Access Compliance Report

Public Rights-of-Way

(Curb Ramps)

| Intersection ID: 14294 | Main Street: EAST_BV | Cross Street: EUCLID_AV | Location: SW |

| ADA ID: 94E5C053F6A5 | Ramp Type: Directional1 | Initial Pass/Fail: Fail | Overall Compliance: No |

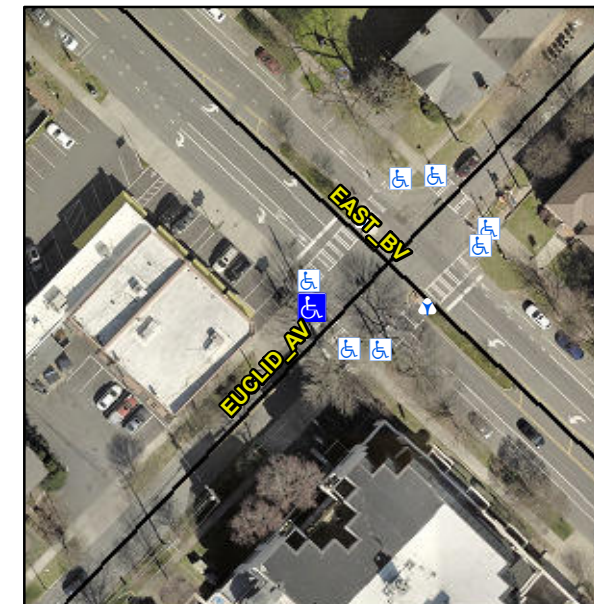
R304.5.3

| Compliance | Description | Data | Compliance | Description | Data |
|------------|-----------------------|-------|------------|-----------------------------|------|
| No | Ramp XSlope (%) | 5.9 | | | |

Remove & Replace Entire Ramp.
